CITY OF CODY
PLANNING, ZONING AND ADJUSTMENT BOARD
TUESDAY, SEPTEMBER 24, 2013
CITY HALL COUNCIL CHAMBERS @ 12:00 NOON

AGENDA

**CITY OF CODY
PLANNING, ZONING AND ADJUSTMENT BOARD
STAFF REPORT**

**CITY OF CODY
PLANNING, ZONING AND ADJUSTMENT BOARD
STAFF REPORT**

A3.1

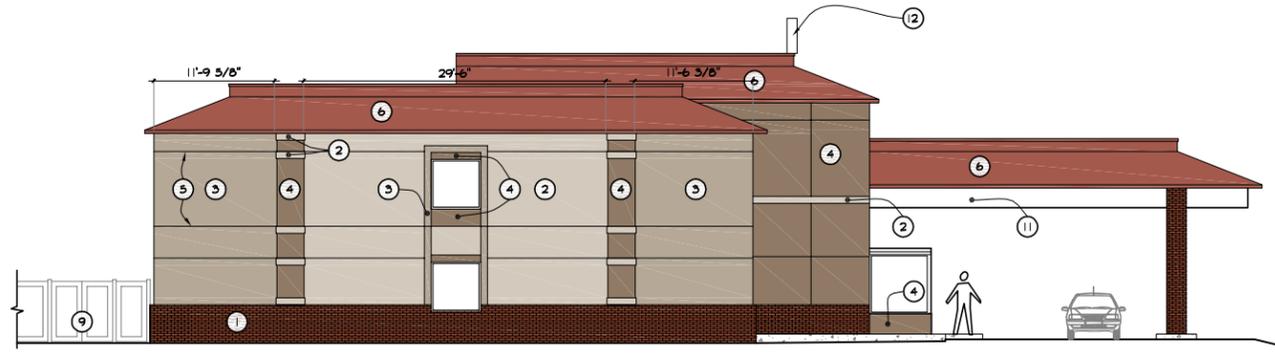
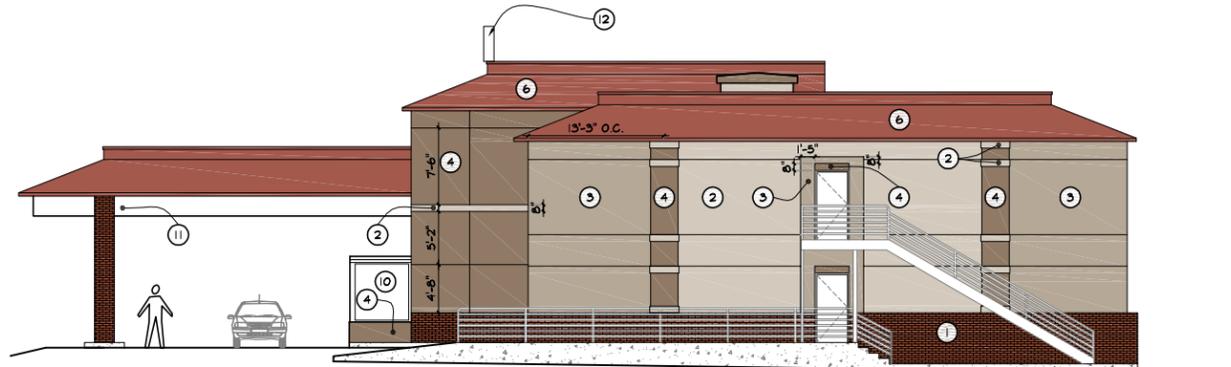
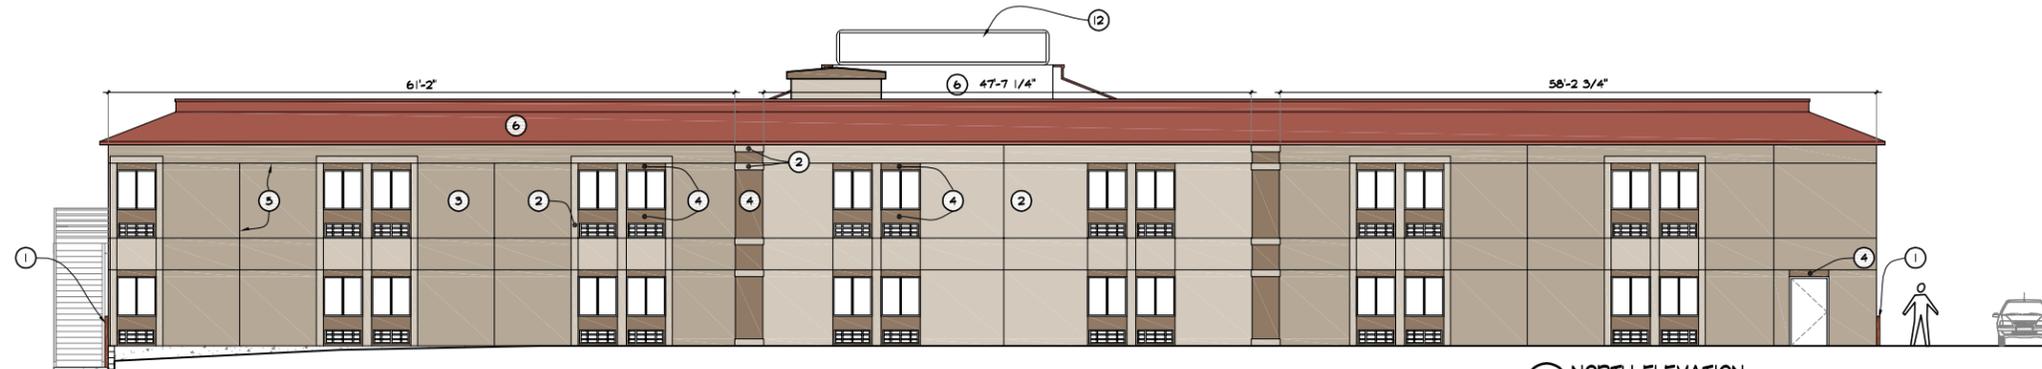
The attached plan and elevations clearly depict the proposal. The proposed colors and materials appear professional and well designed from an architectural standpoint. While more "modern" than the existing wood siding, the EIFS is the siding material of choice for many commercial building developers. The existing siding is clearly showing signs of wear.

SOUTH ELEVATION

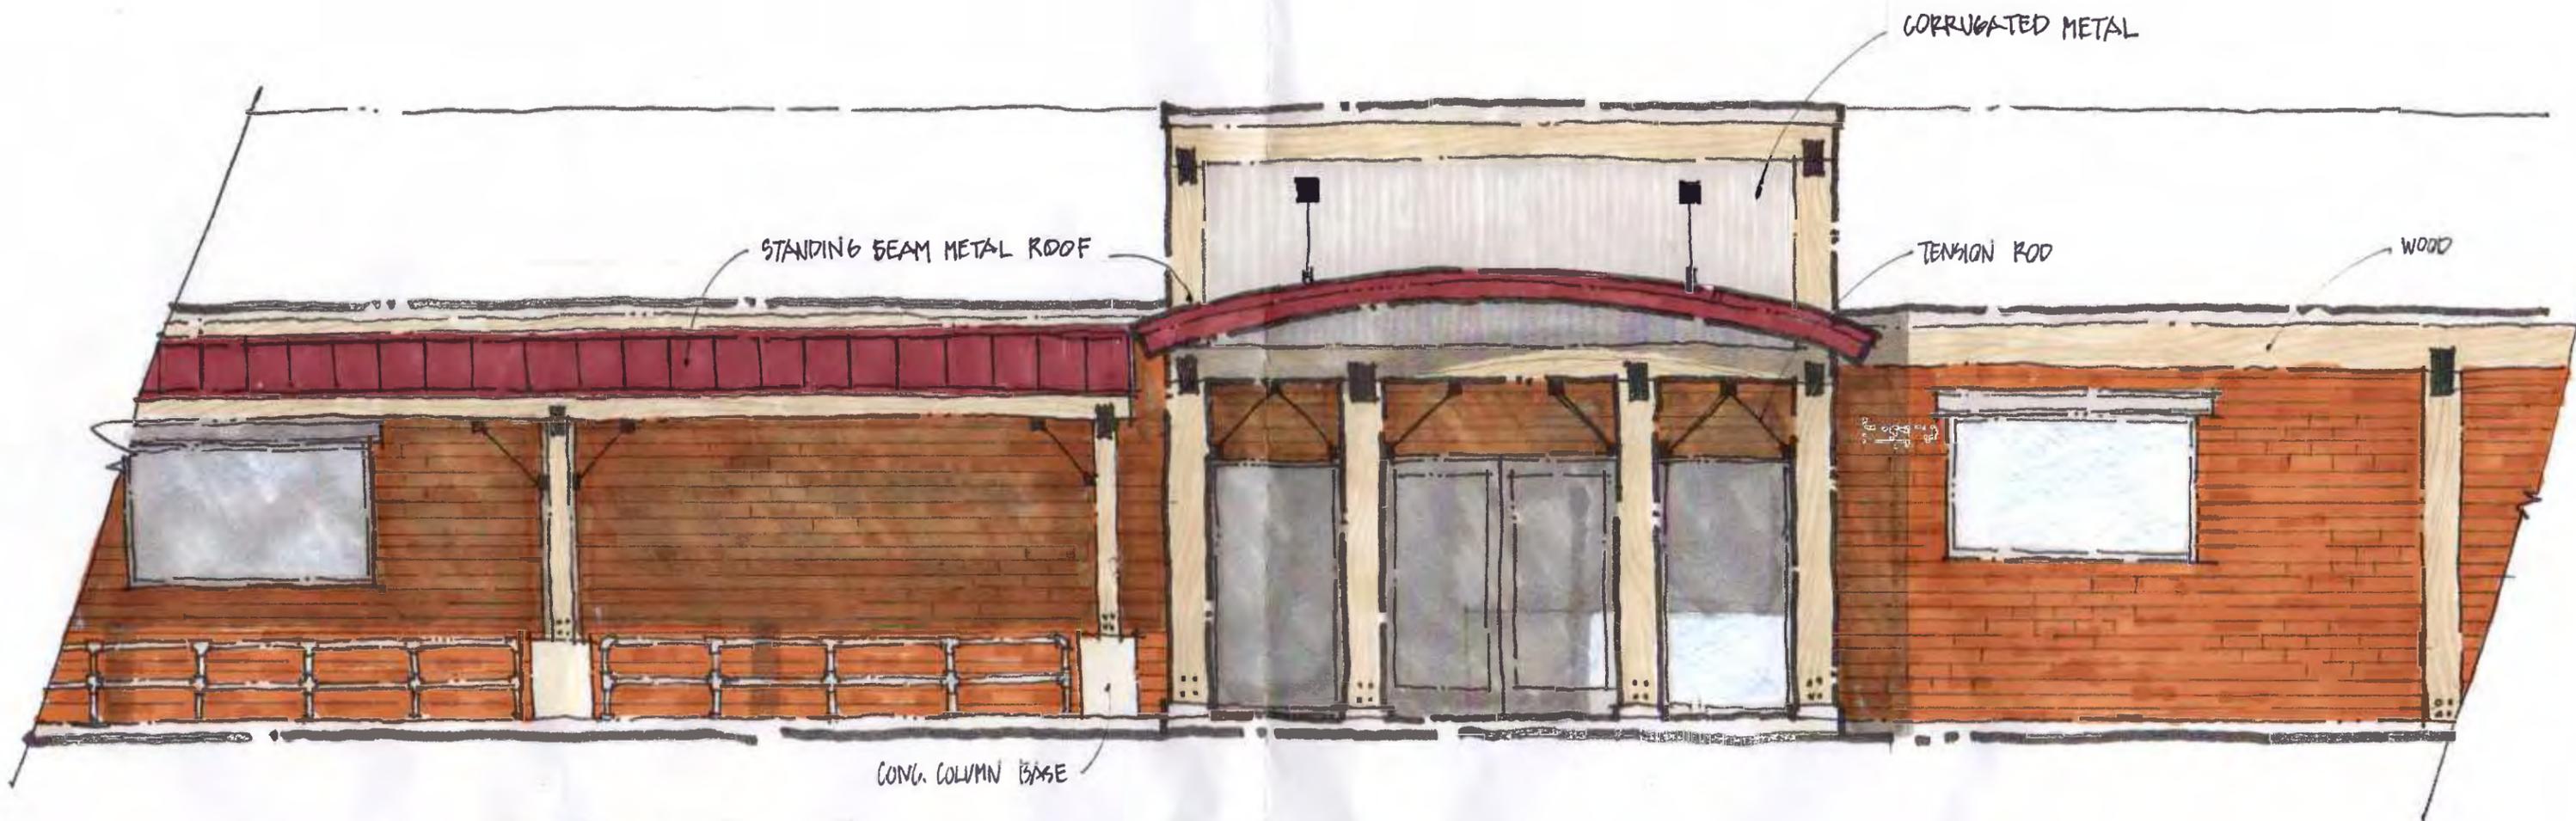
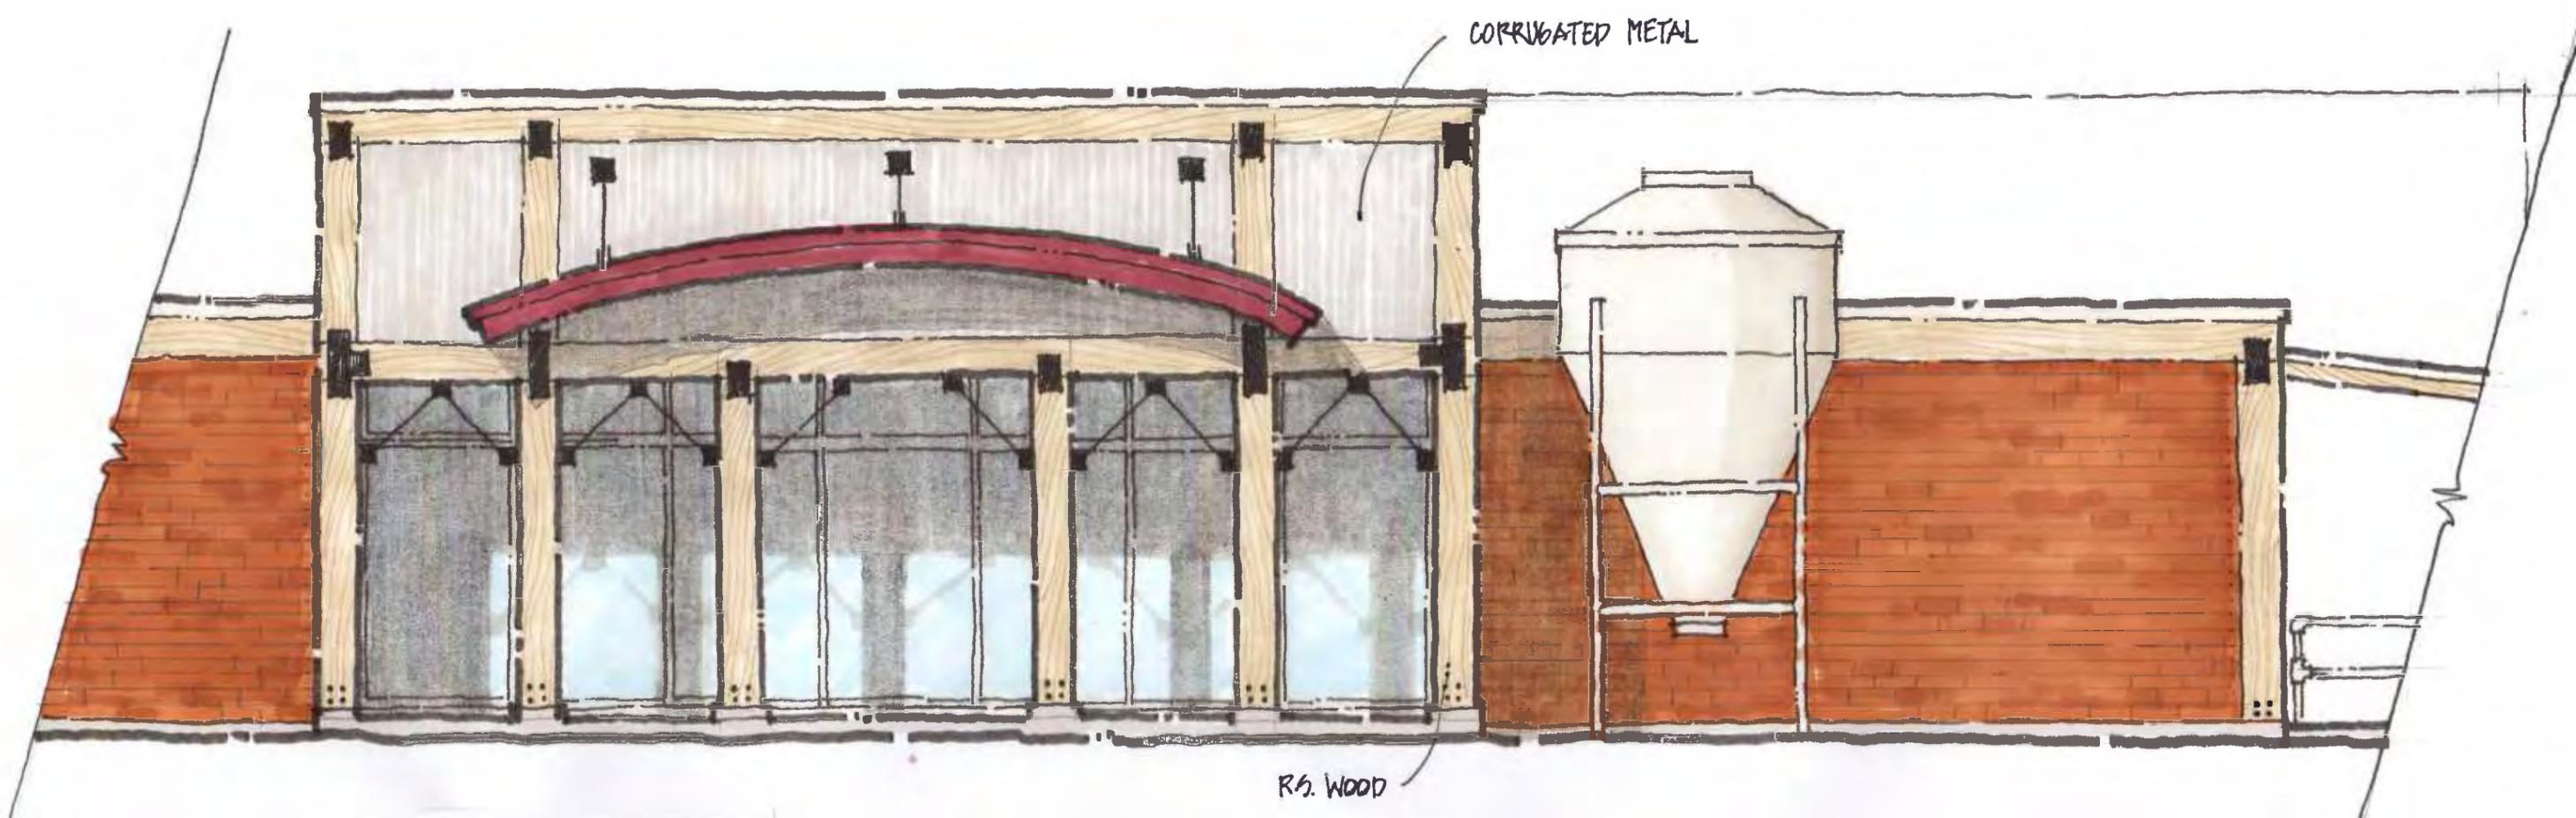
WNT L.L.C. has submitted an application for a modification to the previously approved improvements to the new Millstone Pizza site (former library). The proposal does not affect the approved site plan layout, but includes the following exterior modifications:

- The outdoor seating area will no longer be bordered by a stone planter. Instead, a pipe railing is proposed.
- In place of the new arched roofs at the south and east entrances, awnings of standing seam metal roofing with corrugated rusted metal accent and wood beams are proposed (see attached renderings).

Approve the proposed modifications to the Millstone Pizza architecture, including new arched entryways at the south and east entrances and the railing for the outdoor patio.

Final Plat drawing.
Site Plan.

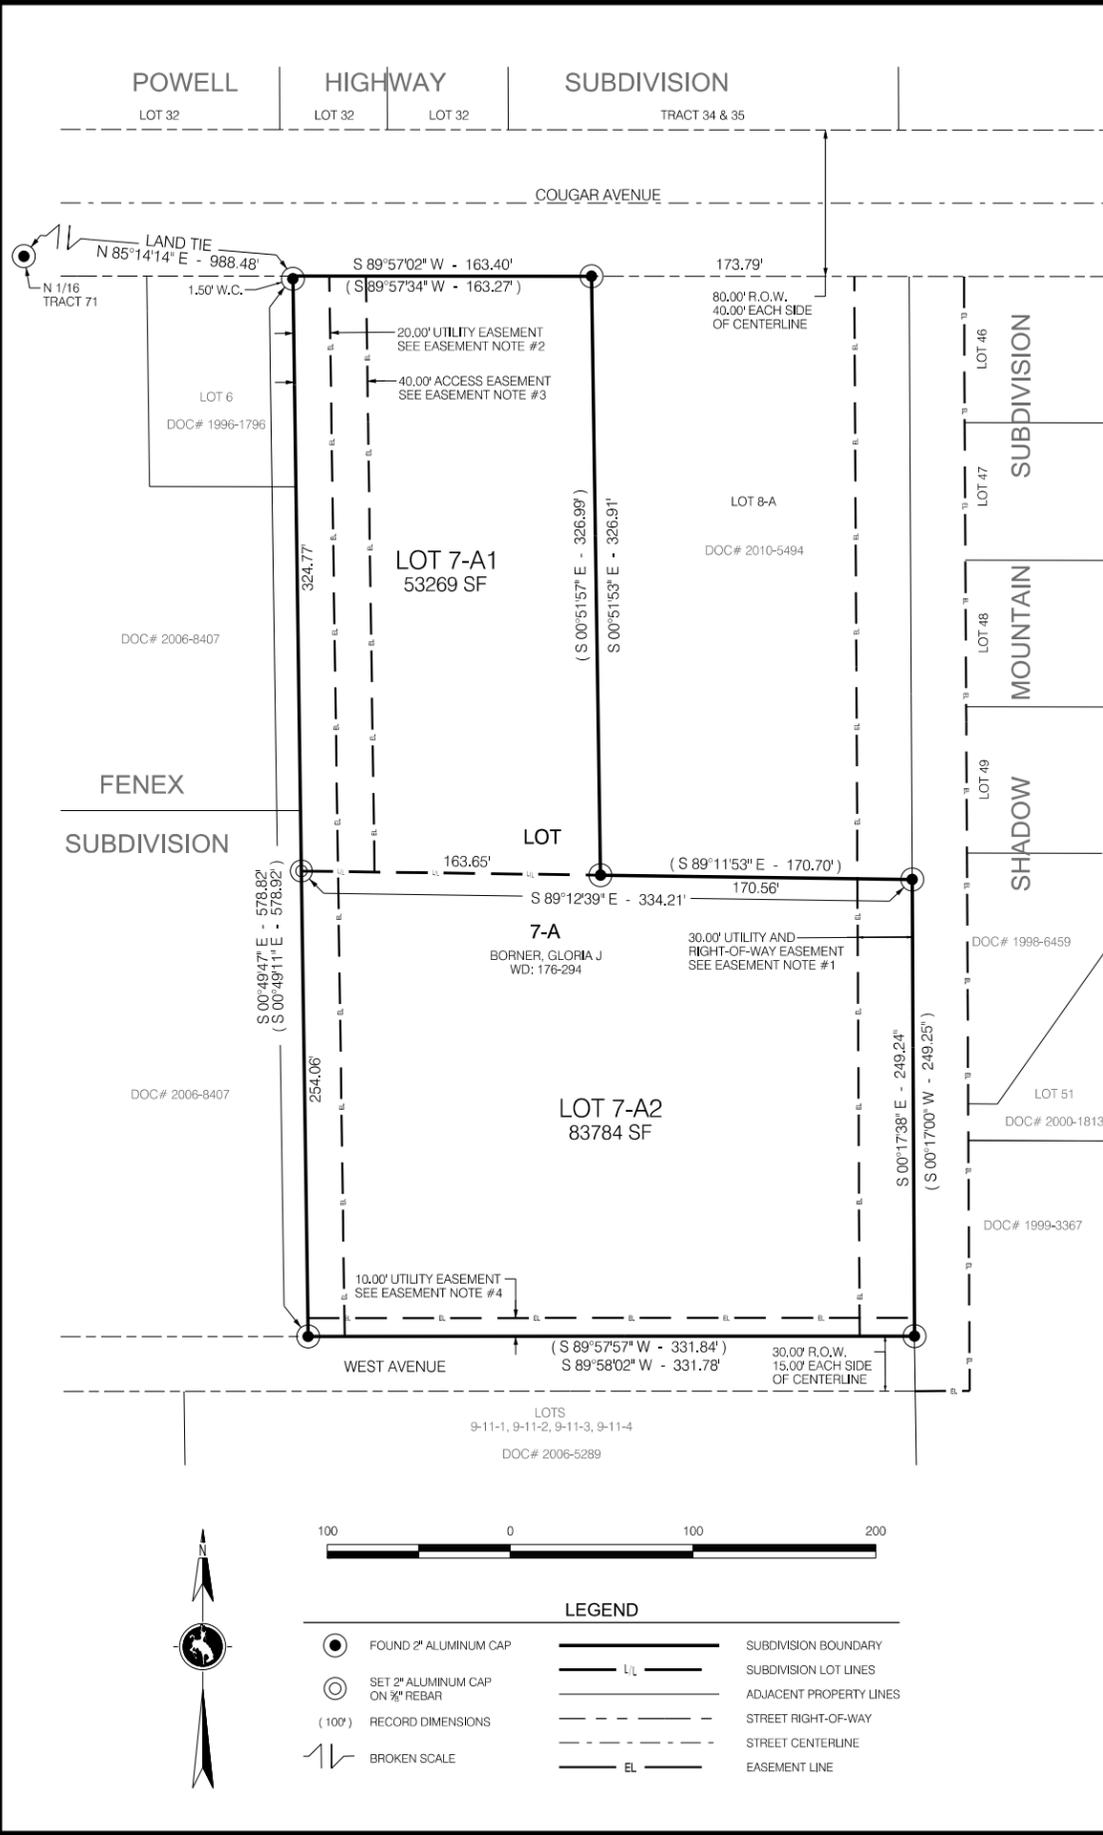
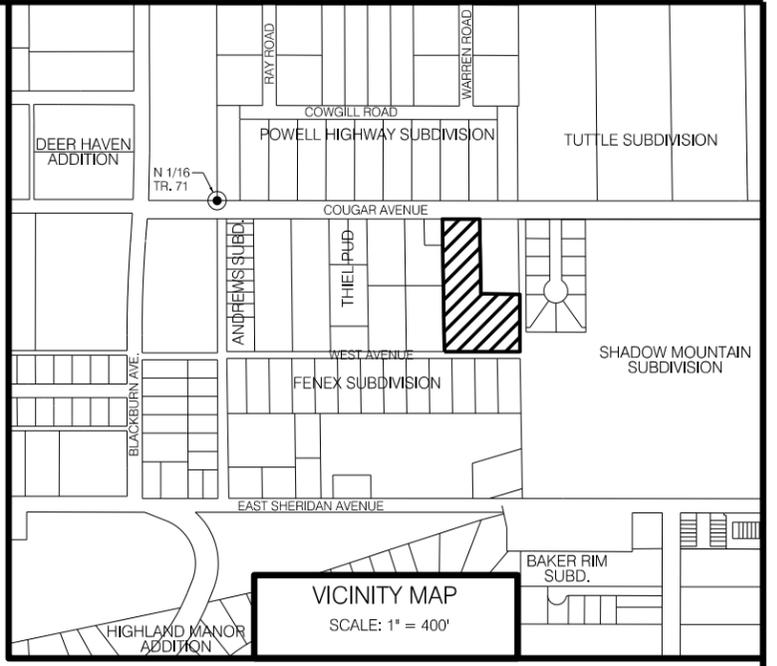
2. Provide a city easement for the water line loop between Cougar Avenue and West Avenue.
Status: A 20-foot wide utility easement is shown on the final plat for this purpose.

3. Provide utility easements as required by the utility providers. At a minimum, provide 10-foot utility easement along West Avenue, and a 10-foot wide power easement for the loop system described by the City Electrical Engineer.
Status: As of the time of this staff report, a letter from Energy West had been received. Letters from TCT, Optimum/Charter, and Cody Canal are pending. It is expected that an easement for the irrigation canal/ditch along Cougar Avenue will be required by Cody Canal. The 10-foot utility easement along West Avenue is provided, yet the power easement is lacking and needs to be added.

6. Note the variances granted on the final plat.
Status: The variances are generally noted on the plat, but staff would prefer some modifications to more accurately reflect the language noted in the motions, and to change the tense from future to present.

1. Provide an agreement (backup) between the property owner and surveyor for transfer of the water rights to the City of Cody.
2. Provide utility letters and any easements required by the utility providers (TCT, Optimum/Charter, and Cody Canal).
3. Add a 15-foot wide utility easement across the north end of Lot 7-A2.
4. Modify the variance language as requested.
